**VILLAGE OF VERNON HILLS
ORDINANCE 2024-043**

**AN ORDINANCE GRANTING PRELIMINARY AND FINAL SITE PLAN,
LANDSCAPE PLAN, AND ARCHITECTURAL PLAN APPROVAL FOR A NEW
LIGHT INDUSTRIAL AND OFFICE BUILDING FOR ANTON PAAR TO BE
LOCATED AT 600 HICKORY HILL DRIVE**

EXHIBIT A

Anton Paar – 600 Hickory Hill Drive

1 SITE PLAN - ELECTRICAL PHOTOMETRIC
1/20" = 1'-0"

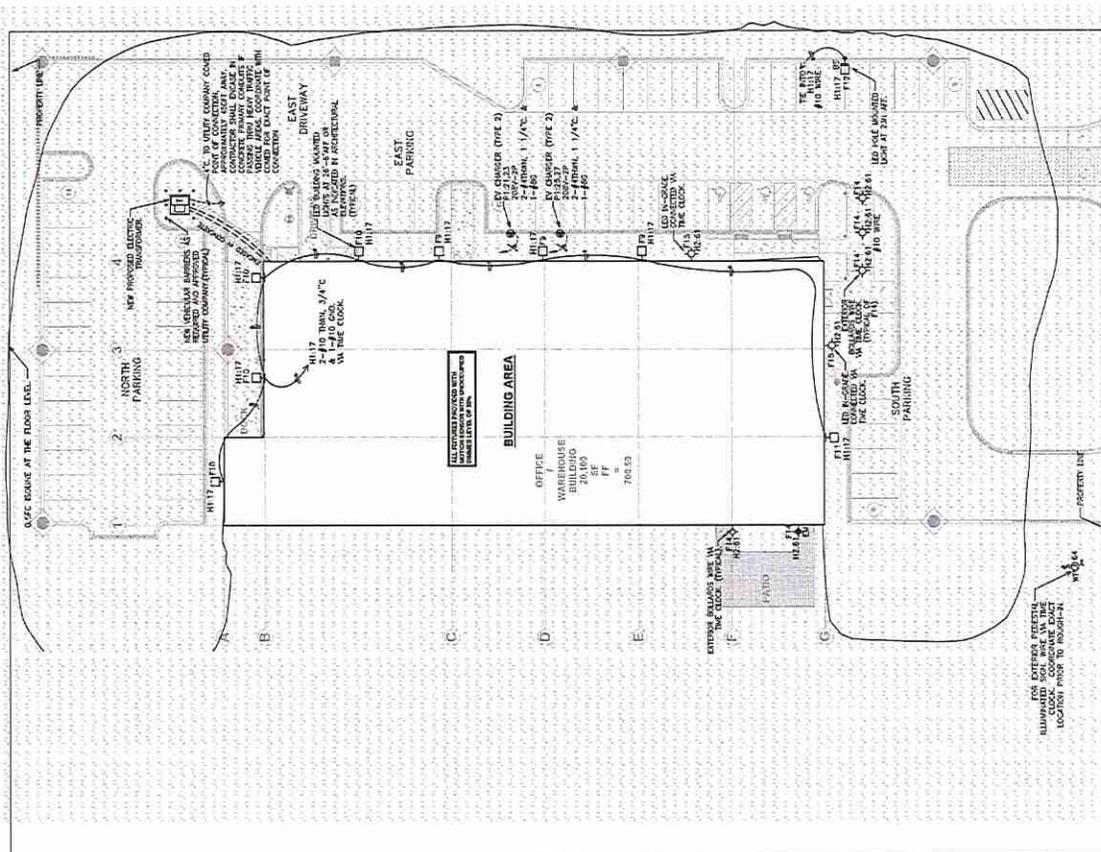
Commissioner Smith referred to the photometric plan. He noted that light level in the northwest corner was higher and appears to spill over to the west. By comparison the east side doesn't have the same issue. It doesn't go over property line but it extends past the parking lot. Mr. Heitman agreed that they could look into solutions. Chairman Morris asked if Commissioner Lis would agree to an amendment to the motion to include a condition of approval to address light spillage.

1. The photometric plan shall be reviewed at permit, particularly with respect to light spillage at the northwest corner of the building.
